Consumer Product Service
Manager of Tehnical Support
FIELD CHANGE ORDER number **1A**

MODEL:2600A ATARI Video Computer System

Consumer Product Service
Manager of Technical Support
UPGRADE BULLETIN

MODEL: Atari CX5200 Supergame (PCB CA018087)

Figure 1. Resistor/Capacitor Fix

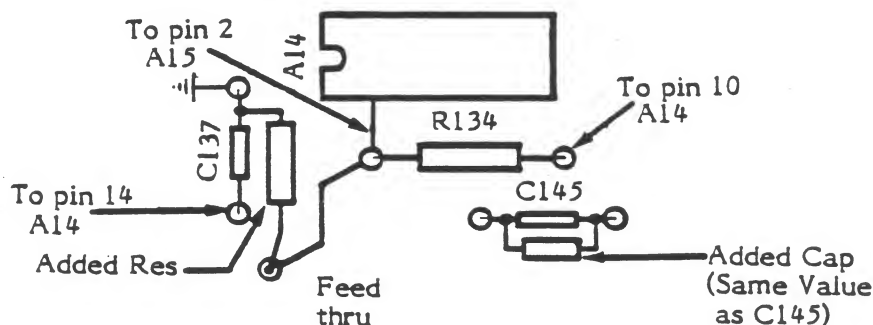
The timing of some Signetics I.C.'s causes RAM information to be distorted. This results in a scrambled screen display or worse - no video at all.

C145 (C014179-24) should be paralleled with another 390pf capacitor (C014179-24) and a 470 Ohm resistor (14-5471) be added from C137 to R134 (See Figure 1).

If the unit still displays a faulty screen, swapout A16 and A17 with another vendor's component. DO NOT USE A SIGNETICS I.C.

Figure 1. Sleeve Buss Wire Placement

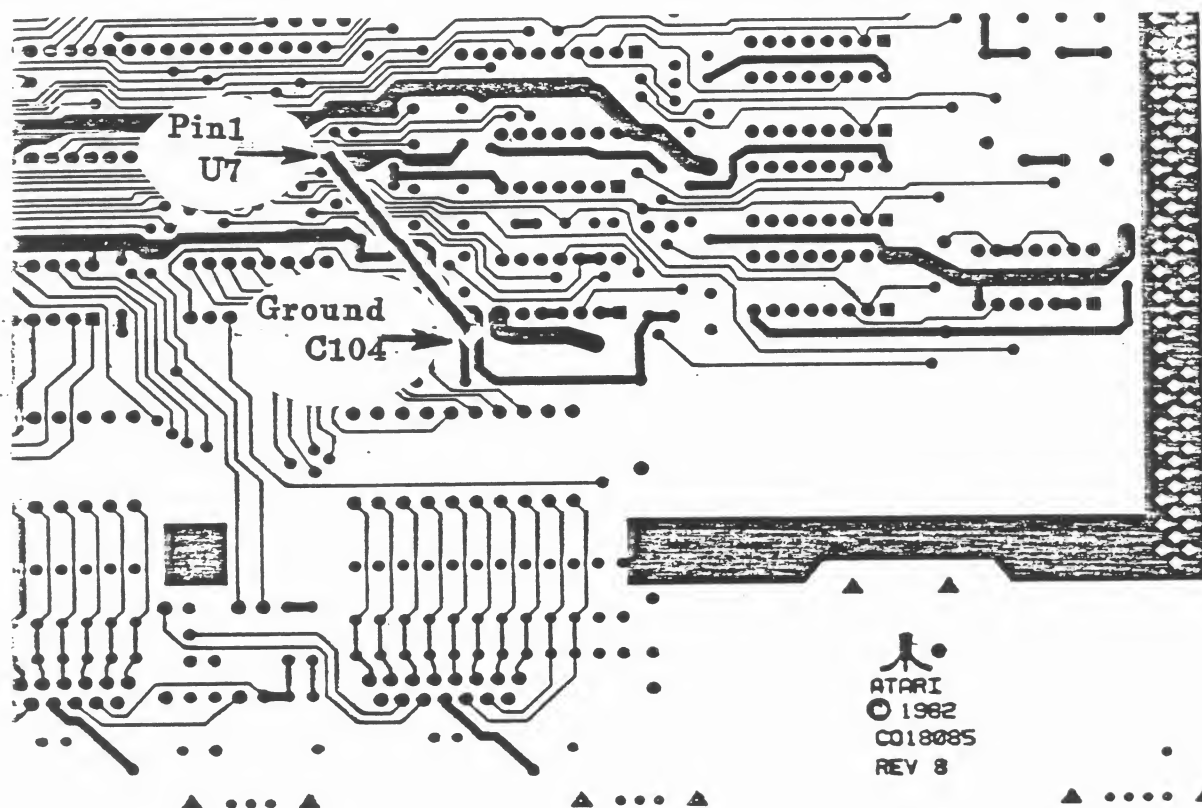
Some 5200 PCB's demonstrate paddle jitter caused by a ripple on the +5v power supply to the POKEY IC (U7), and an inadequate ground trace at Pin 1 of U7.

To eliminate paddle jitter a 10uf capacitor (C017516) must be soldered directly across the +5v and ground legs (Pins 1 and 17) of U7. A sleeved jumper wire must also be connected between Pin 1 of U7 and another ground trace.

- 1) Trim Capacitor to an overall length of 1 5/8 - 1 3/4 inches.
- 2) Cover the capacitor leads with sleeving. Approximately 1/8 inch of the lead must extend beyond the sleeving for soldering.
- 3) Solder the "+" lead of the cap to Pin 17 of U7 (+5 volts). Solder to the I.C. Leg
- 4) Solder other cap lead to Pin 1 of U7 (ground). Solder to the I.C. Leg.
- 5) Cover 1 1/4 inches of buss wire with plastic sleeving leaving sufficient length at each end for soldering.
- 6) On the solder side of the PCB solder one end of the sleeved buss wire to Pin 1 of U7. See Figure 1.
- 7) Solder the other end of the sleeved wire to the ground lead of C104. See Figure 1.

Figure 1. Trace Cuts

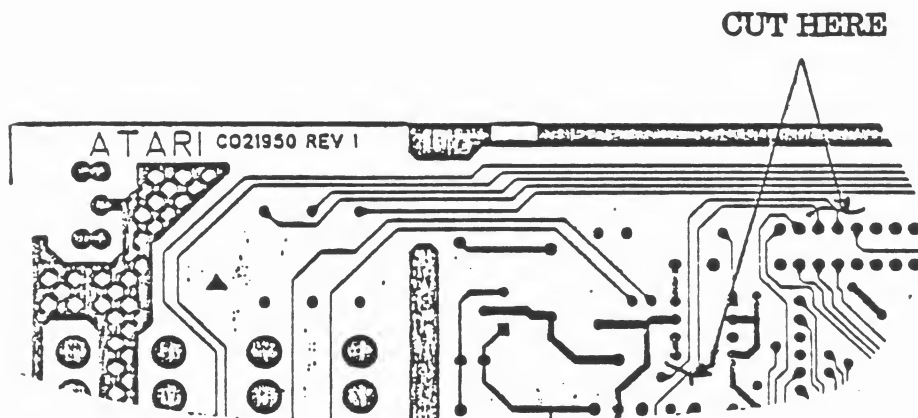
Screen jitters when Ms. Pacman is played.

On the solder side of the PCB, use two jumper wires to reroute traces between J1, Pins 15 and 16 and the data bus (See MODIFICATION PROCEDURES).

1. On the solder side of the Adaptor PCB, carefully cut the traces shown in Figure 1.

Figure 2. Jumper Wire Placement

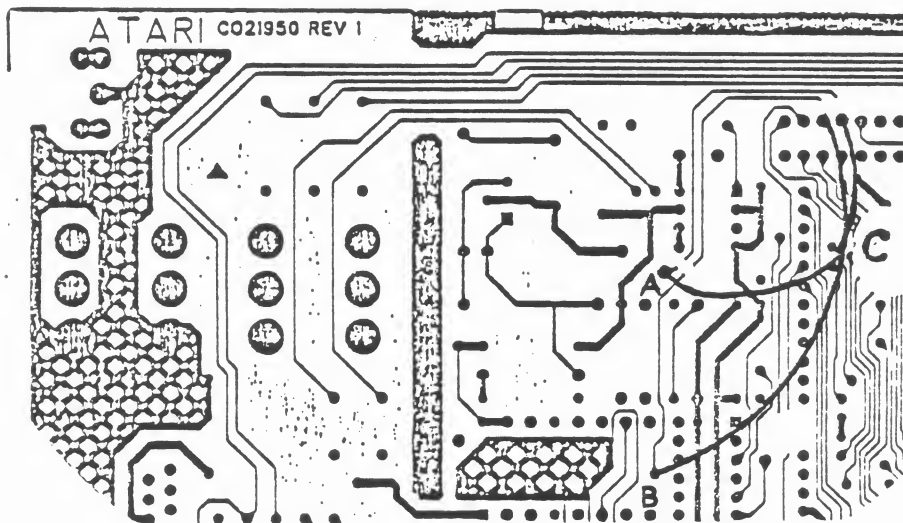
2. Wrap one end of the jumper wire around Pin 15 of J1, and attach the other end of the wire to the feed-thru identified as A in Figure 2 (below R9).
3. Wrap one end of another jumper wire around Pin 16 of J1, and attach the other end of the wire to the feed-thru identified as B in Figure 2 (near the ends of C12 and R14).
4. Use a non-conductive material and tack the jumper wires to the board. Tack the wires at locations identified as C in Figure 2.

Figure 1. Spacer Installation

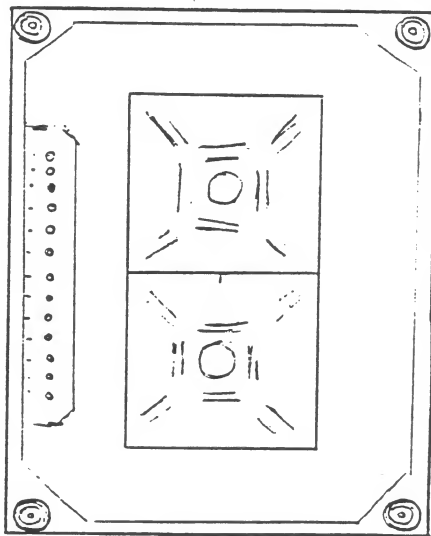
The backing of the telephone-style keypads used on the 5200 Retail Demonstrator have been breaking because of insufficient support.

- 1) Remove the four nuts and washers that hold the keyboard plate to the control panel.
- 2) Remove the keyboard plate.
- 3) Install spacers (see Figure 1).

Figure 1. Hole Cover Placement

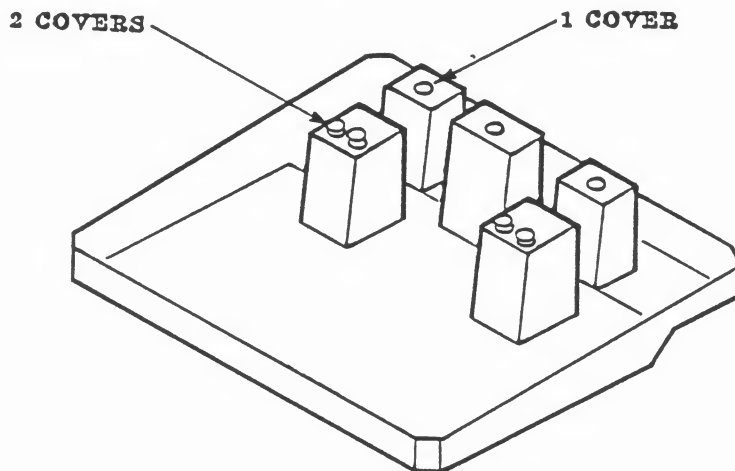
- 1) The metal domes under the fire buttons shift around under the mylar sheeting causing sporadic contact.
- 2) The 12-button keypad or the SELECT keypad slips under the top case.

Use eleven ATARI 810™ Disk Drive hole covers (C014106) and place them in the positions on the bottom case shown in Figure 1.
